Product Change Notice (PCN)

PCN Number: **PCN-0451150R-01**

Product(s) Affected: PJ-037AH

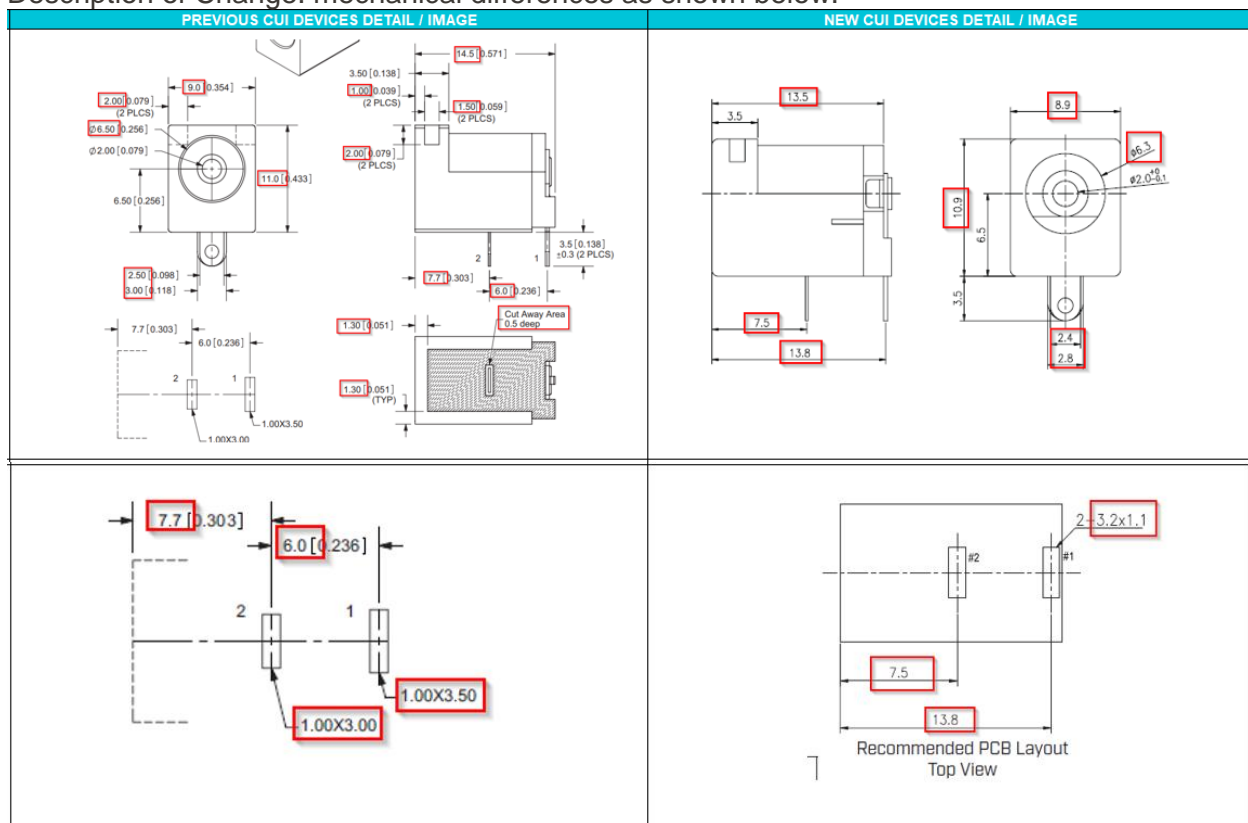
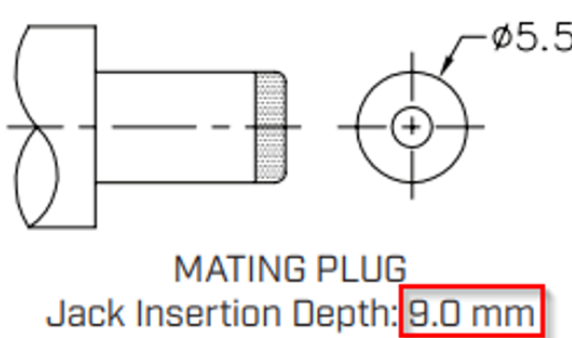
Description of Change: mechanical differences as shown below:

MATERIAL	PLATING
center pin	copper	nickel
terminal 1	brass	silver
terminal 2	copper alloy	silver
plastic	PBT

DESCRIPTION	MATERIAL	PLATING/COLOR
center pin	copper alloy	nickel
terminal 1	brass t=0.3 mm	nickel-silver
terminal 2	phosphor bronze t=0.3 mm	nickel-silver
housing	PBT (UL94V-0)	black
cover	PBT (UL94V-0)	black

MATING PLUG
Jack Insertion Depth: 9.0 mm

MATING PLUG
Jack Insertion Depth: 9.8 mm

Insertion/extraction force adjusted to 0.3 ~ 2.0 kg
